**PEACH CREEK ENVIRONMENTAL PARK
SAN JACINTO COUNTY, TEXAS
TCEQ PERMIT APPLICATION NO. MSW 2406**

Technically Complete Application

Addendum 2 to Volume 2, Part III of the Technically Complete Application

**TYPE I PERMIT APPLICATION
PART III – SITE DEVELOPMENT PLAN**

C 3.2

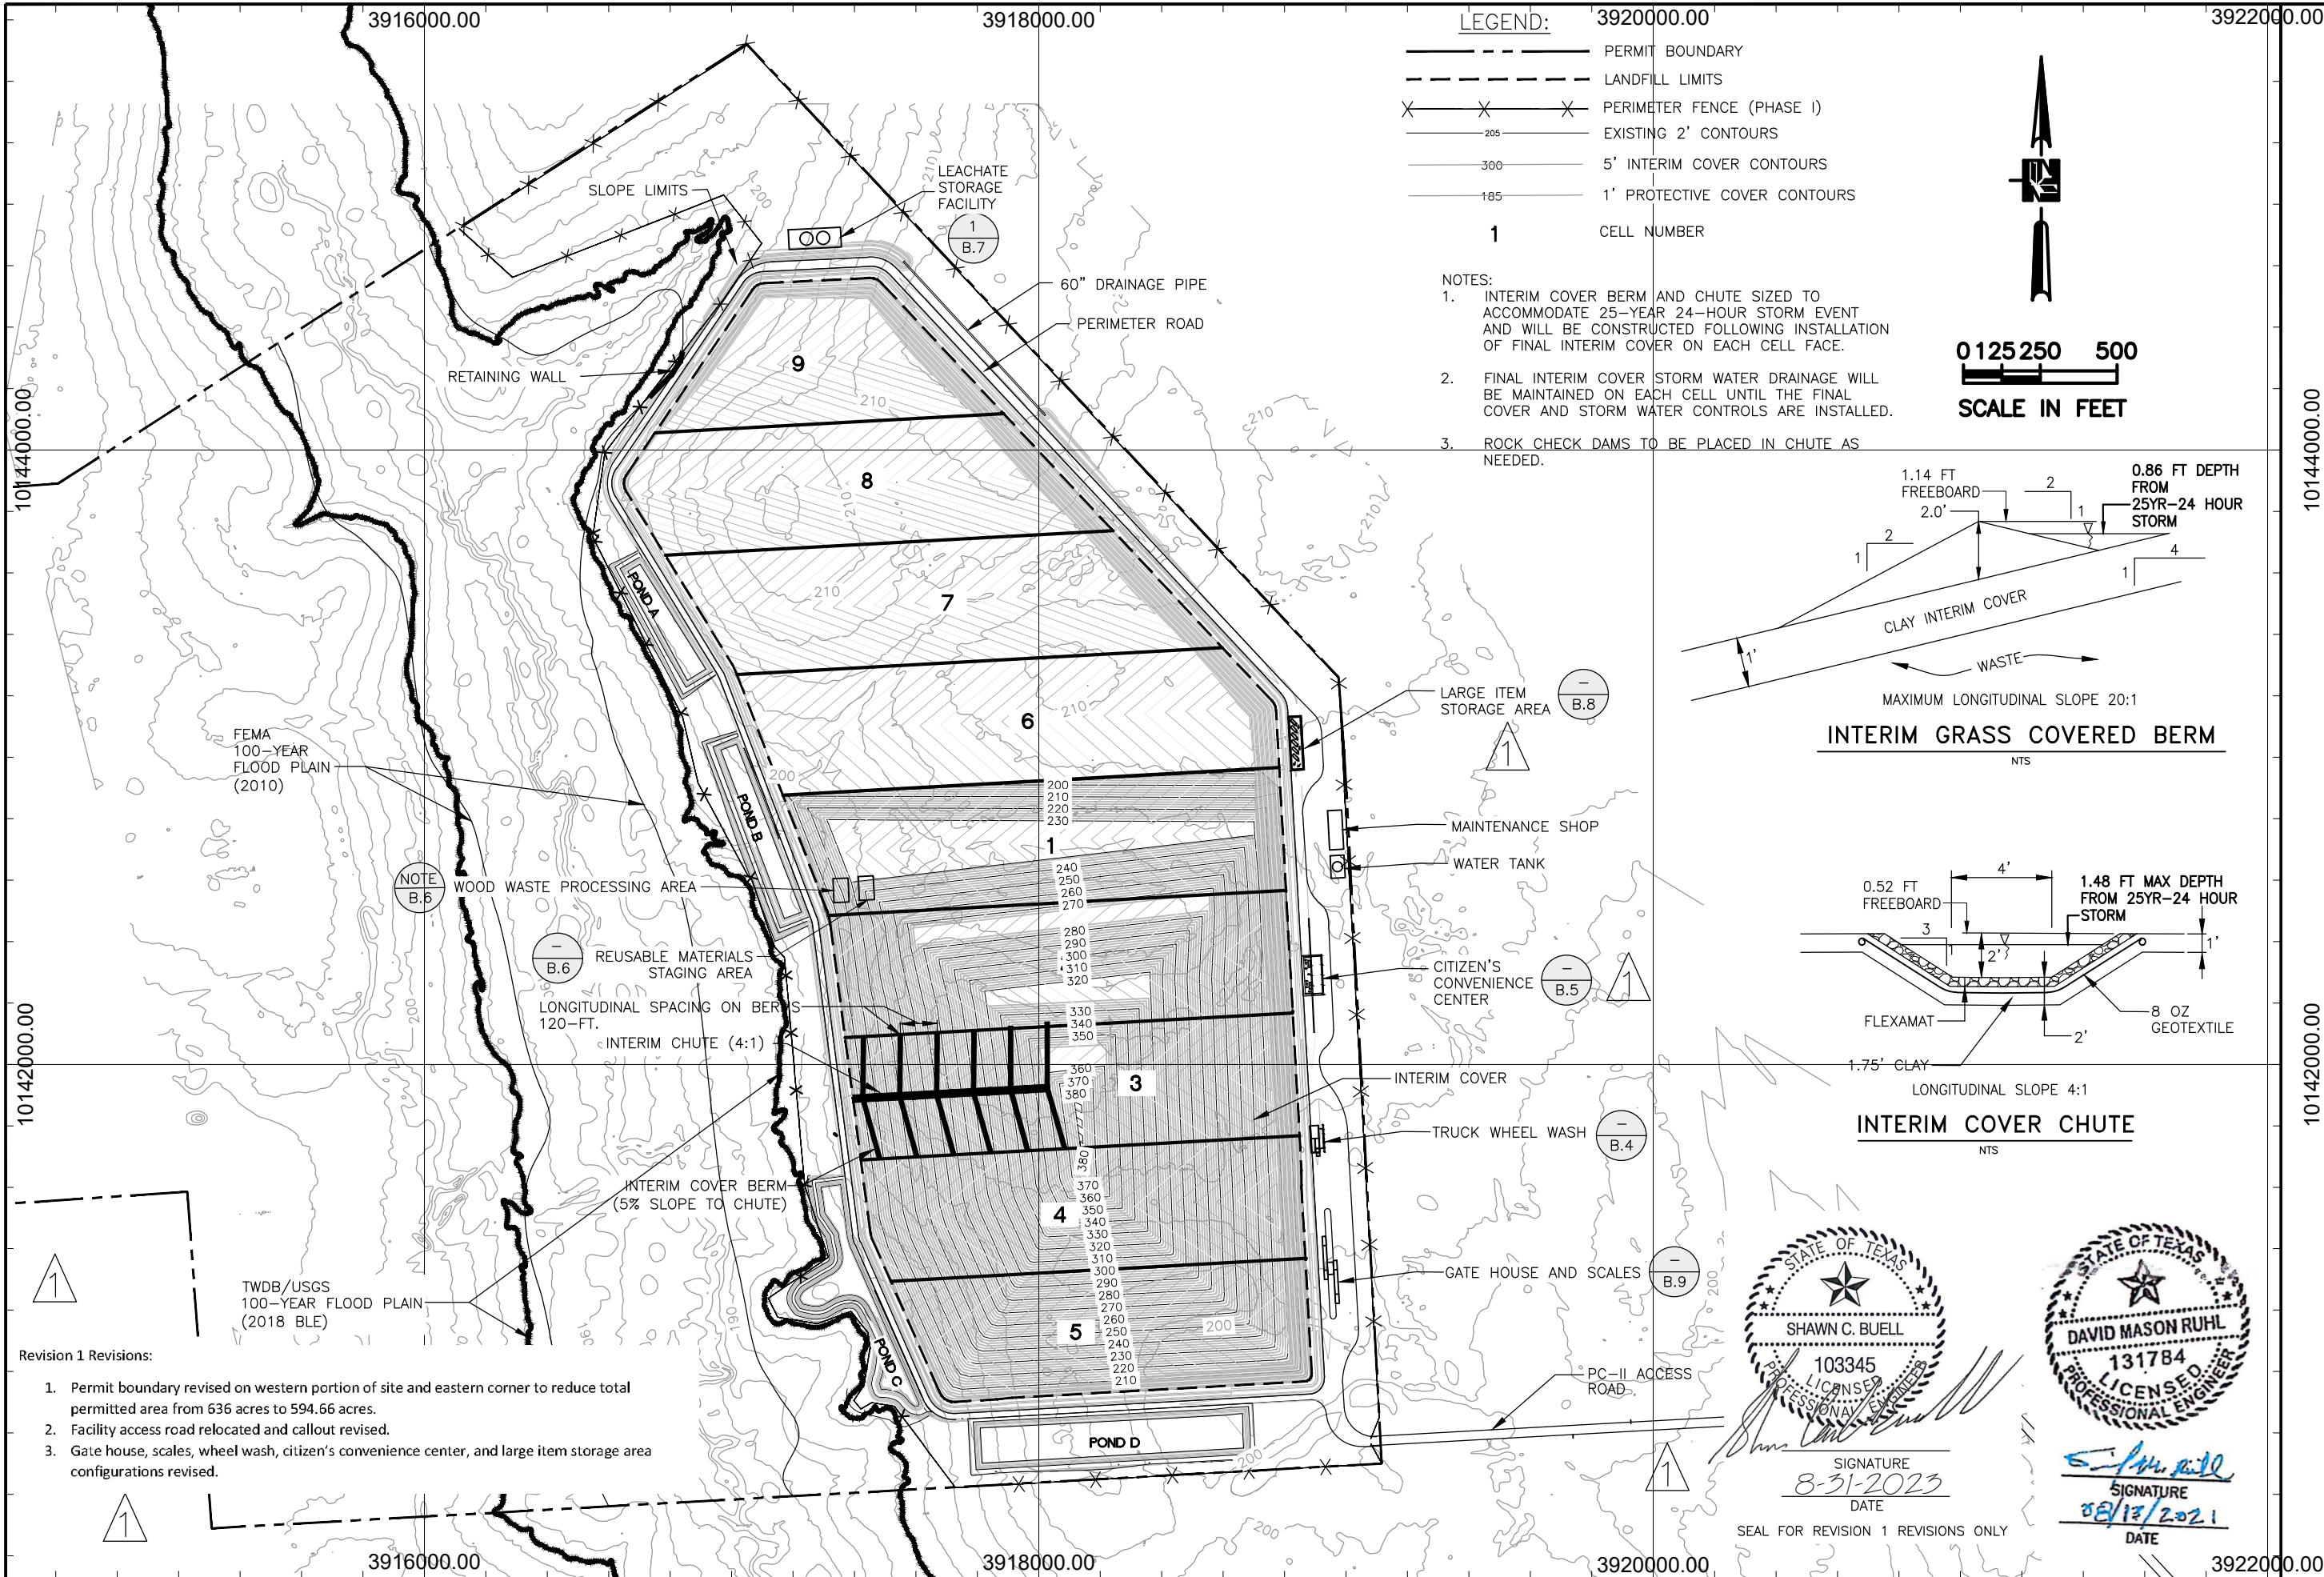
- Revision 1 Revisions:**
- Permit boundary revised on western portion of site and eastern corner to reduce total permitted area from 636 acres to 594.66 acres.
 - Facility access road relocated and callout revised.
 - Gate house, scales, wheel wash, citizen's convenience center, and large item storage area configurations revised.
